04	ADDENDUM NO. 01	2014.10.21
03	ISSUED FOR BID	2014.09.16
02	ISSUED FOR 99% PROGRESS REVIEW	2014.08.25
01	ISSUED FOR 66 % PROGRESS REVIEW	2014.06.14
revision		date

project title
titre du projet
PARRY SOUND ONTARIO
28 WALBEEK STREET
P2A 1B9
**CANADIAN COAST GUARD
ROOF UPGRADE**

drawing title
titre du dessin
**BUILDING A - MAIN BUILDING
SHOP WING - ROOF PLAN**

1 PARTIAL ROOF PLAN
1:100

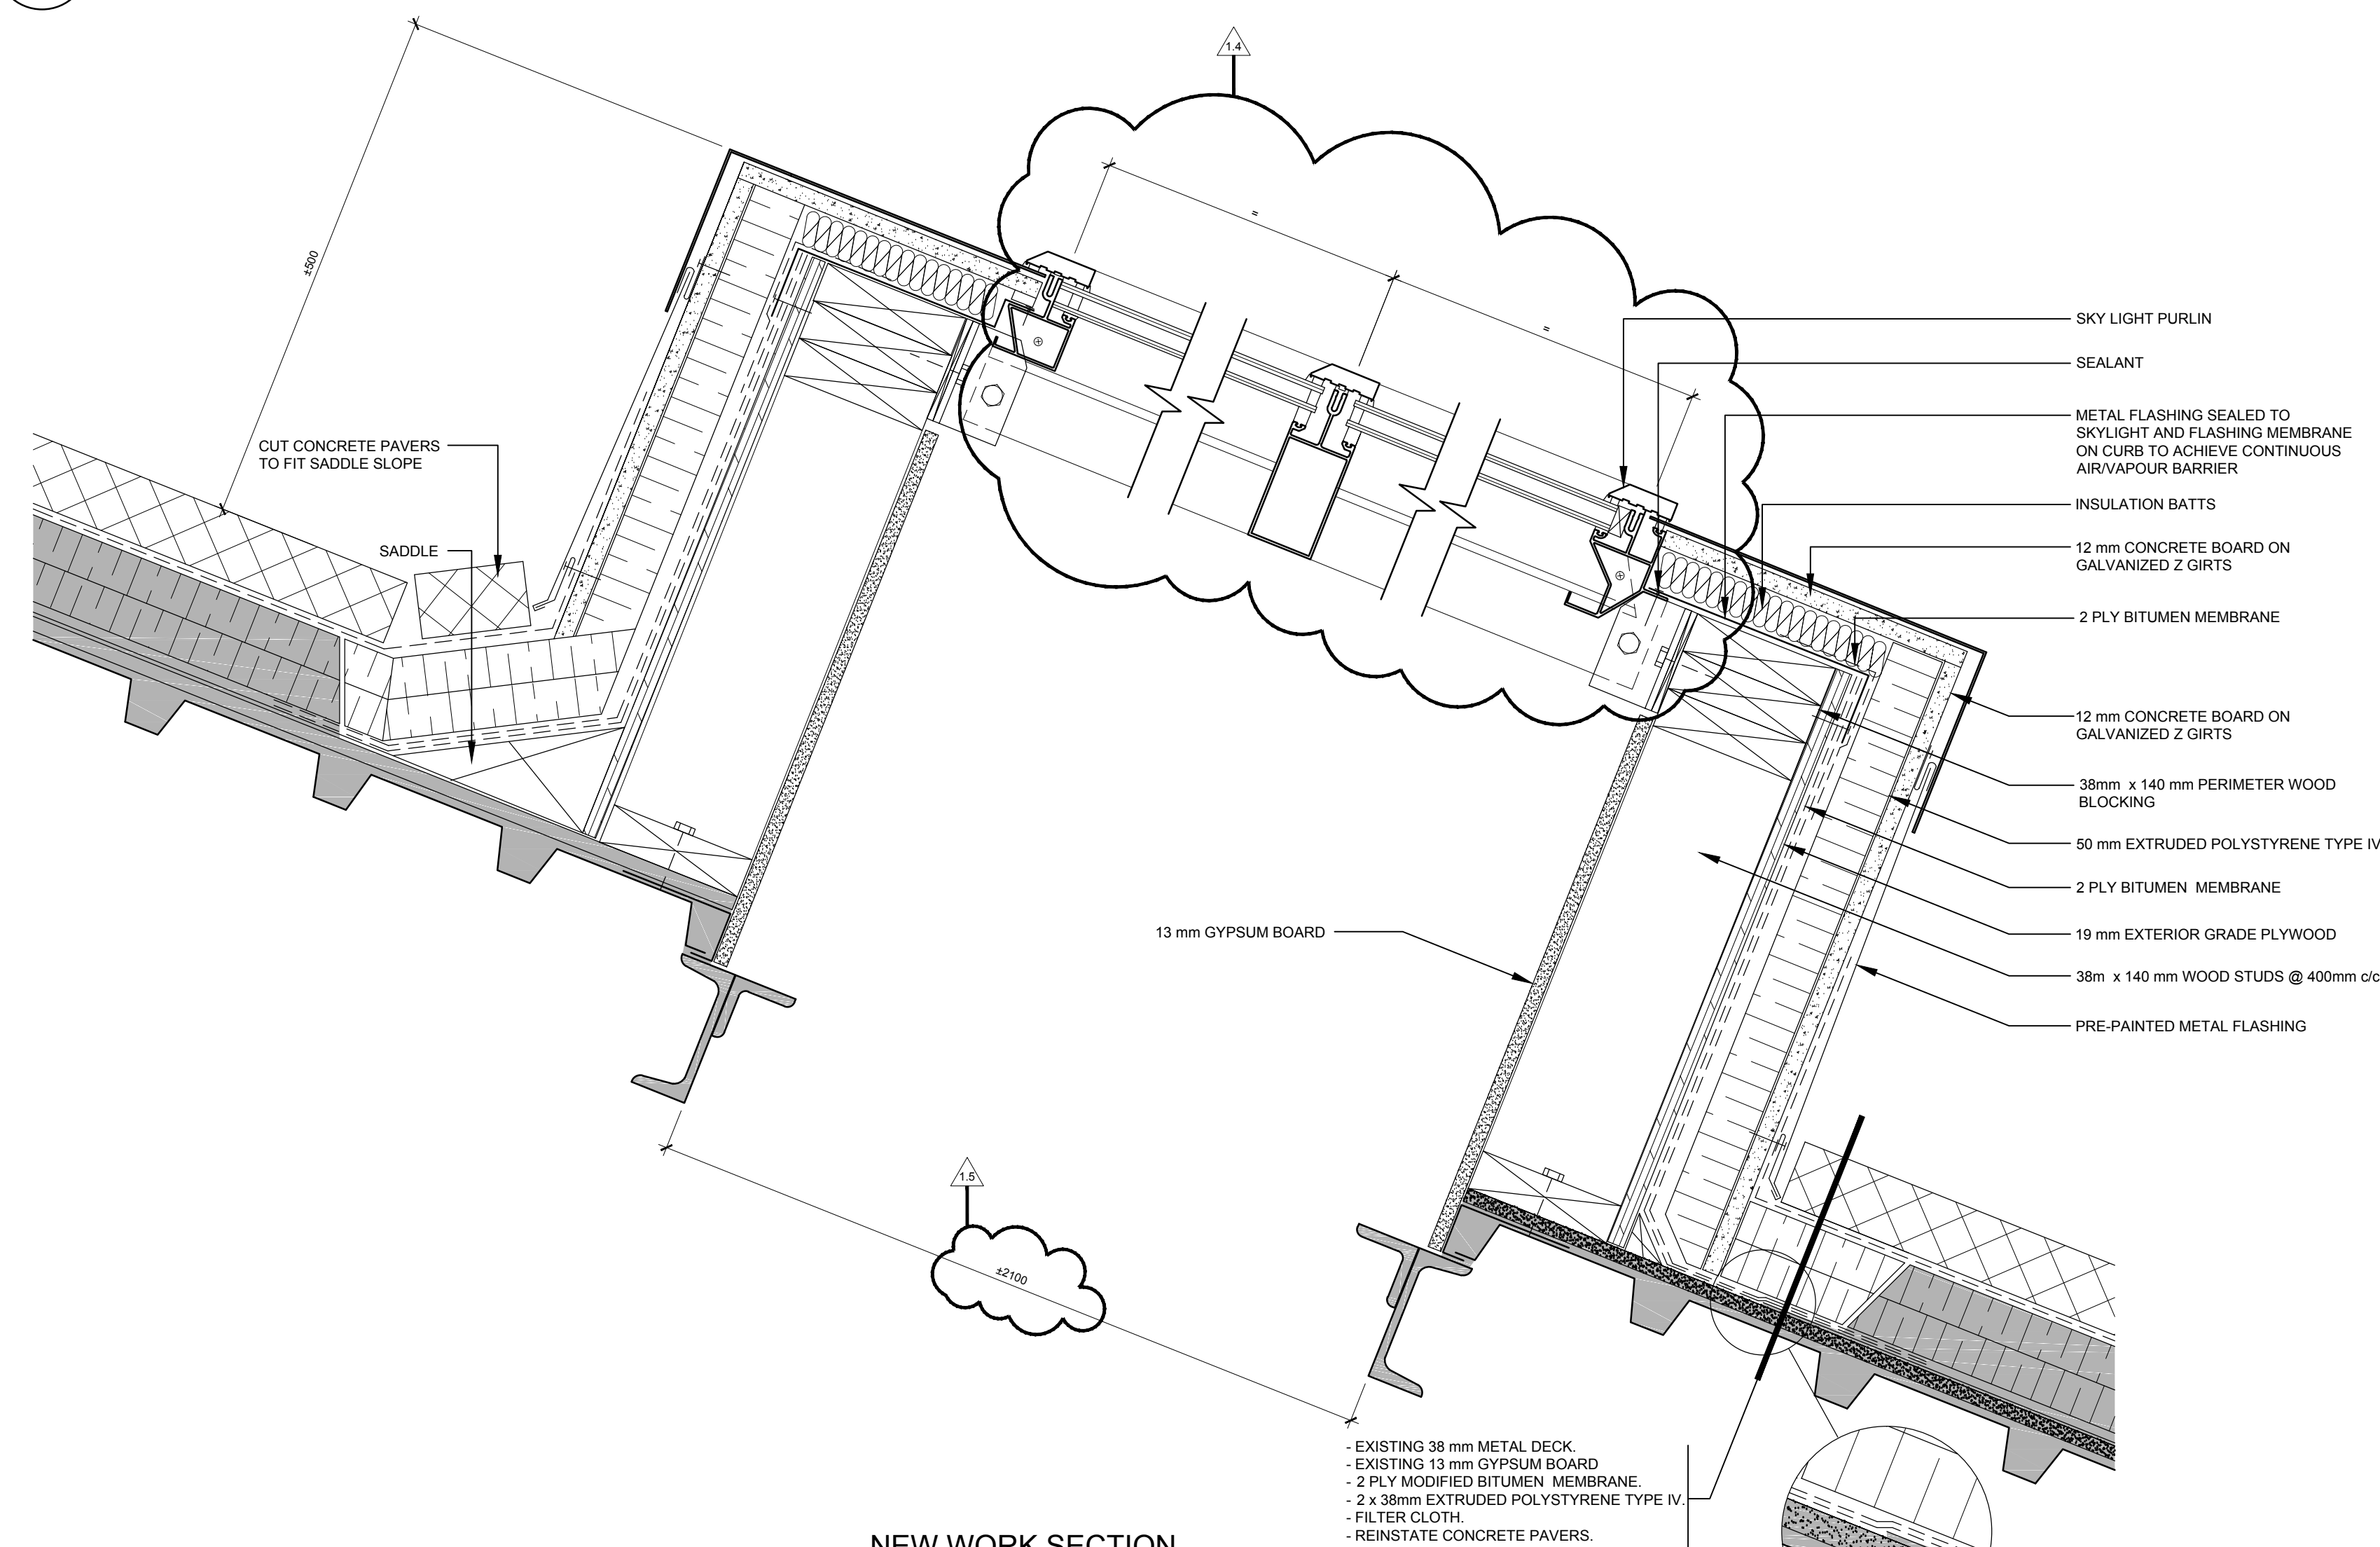
TREE/ROOT REMOVAL : CONTRACTOR TO PROCEED WITH CAUTION IN REMOVING SHRUBS ROOTS. CONTRACTOR TO DOCUMENT LOCATIONS WHERE SHRUBS HAVE BEEN REMOVED ON PLAN & SUBMIT TO CONSULTANT AS DOCUMENTATION, AND NOT IF ANY ROOTS APPEAR TO HAVE ATTACHED THROUGHOUT TO THE ROOFING MEMBRANE OR HAVE CAUSED ANY DAMAGE OR PENETRATIONS TO MEMBRANE. CONTRACTOR TO REMOVE SUFFICIENT CONCRETE PAVERS AND/OR ROOFING AGGREGATES TO ENSURE ROOT STRUCTURE IS FULLY REMOVED. ROOF CONDITIONS NOTED ON PLAN AND PHOTO DOCUMENTATION WHERE PROBLEMS DISCOVERED. CONSULTANT TO REVIEW CONDITIONS BEFORE CONCRETE PAVERS AND/OR ROOFING AGGREGATES RE-INSTALLED.
